Fingerboards Mineral Sands Project Inquiry and Advisory Committee

Technical note

TN No: TN 022

Subject: Response to MFG's request for further information in relation to the water balance modelling

Figure 1 – material removed in hydro-cyclones (around 38 micron)

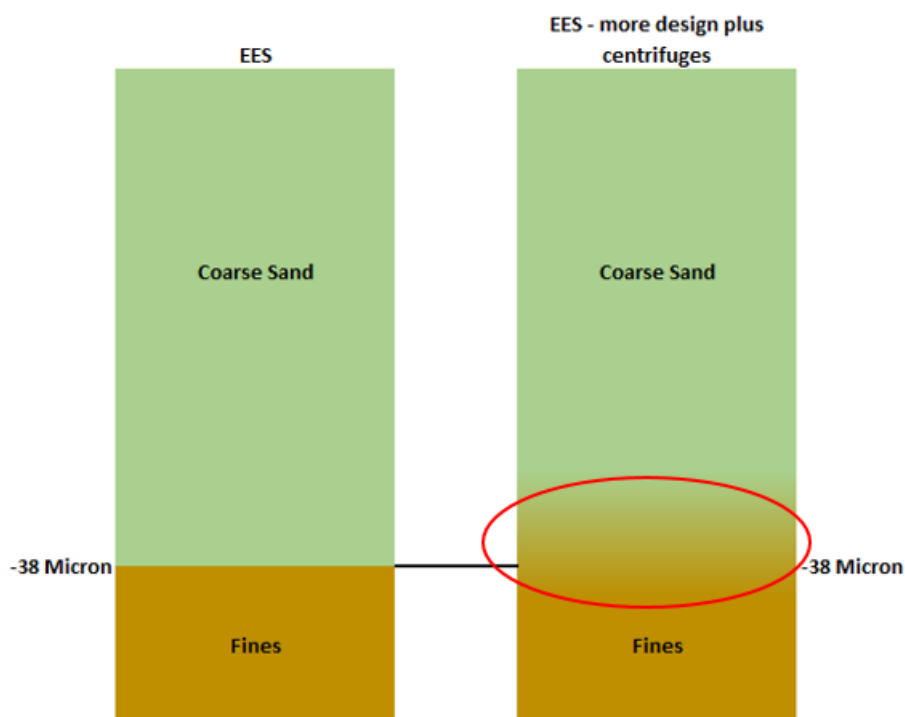
In the EES, it is assumed that the coarse sand mass is the total mass of material greater than 38 micron, less the mass of the HMC and fine tailings removed. However, hydro-cyclones do not “cut” precisely at a specific size, but across a narrow range of sizing. This is simply inherent in the design of hydro-cyclones. Therefore, in order to remove most of the material less than 38 micron, the hydro-cyclones also remove a portion of the material greater than 38 micron, approximately up to 45 micron. This is demonstrated graphically below as the area in the red band. Consequently, the coarse sand tailings mass reduces (Ref 1) and fine tailings mass increases (Ref 7).

The practical effect of this is that there is more silt mass going to the centrifuge plant as fines and slightly less silt going to the mine void as coarse sand, than what was assumed in the EES. Because there is less coarse sand going to the mine void, less water is going to the void in the sand slurry - this is the other reason for the reduction from 17,850 to 11,787 tph for the sand tails (Ref 1).

Figure 2 – clay:silt ratio and absorbed water content

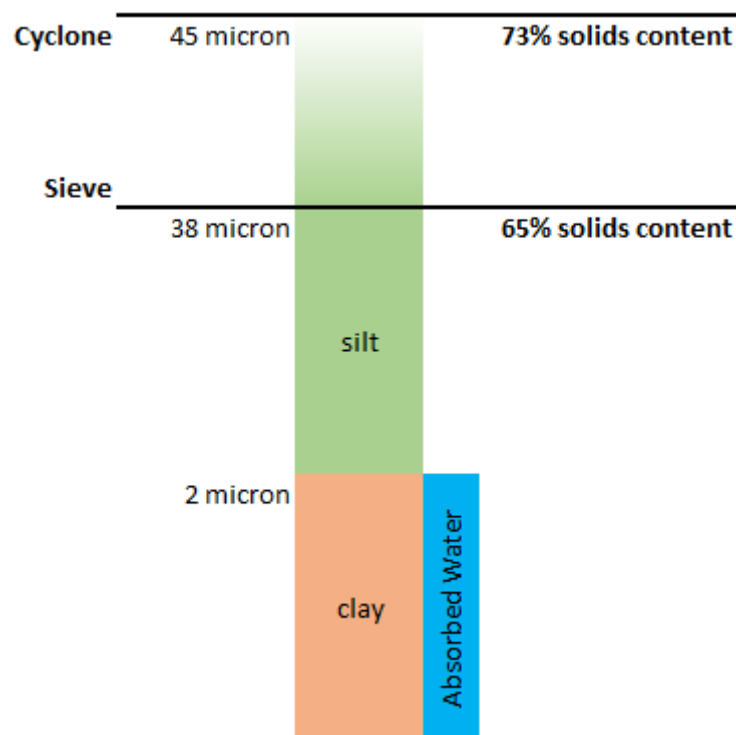
Fines tailings contain a proportion of clay and a proportion of silt particles. Clays are the only particles that actively absorb water. If there is less silt and more clay, then the final cake moisture is higher even though there is no free water. Likewise, if the silt is higher and the clay is less, then the final cake moisture will be less and still have no free water. In other words, the absorbed water content can remain constant, even when the solids content changes.

In larger operations and demonstration programmes, the fines are not removed by sieve, but through hydro-cyclones. As explained in section 3.2, the cyclone will tend to cut coarser than the sieve when removing the minus 38 micron particles which carries over a portion of the material up to 45 Micron into the fines. Therefore, the centrifuge feed during operations will contain a higher percentage of silts than the sieve material used in the P1 trials. This is planned and does not affect the validity of the trials as it is an expected condition for the laboratory test program. In the larger P2 trials the fines will be removed with an identical cyclone proposed for the P3 operational plant.

This is graphically illustrated in Figure 2 below.
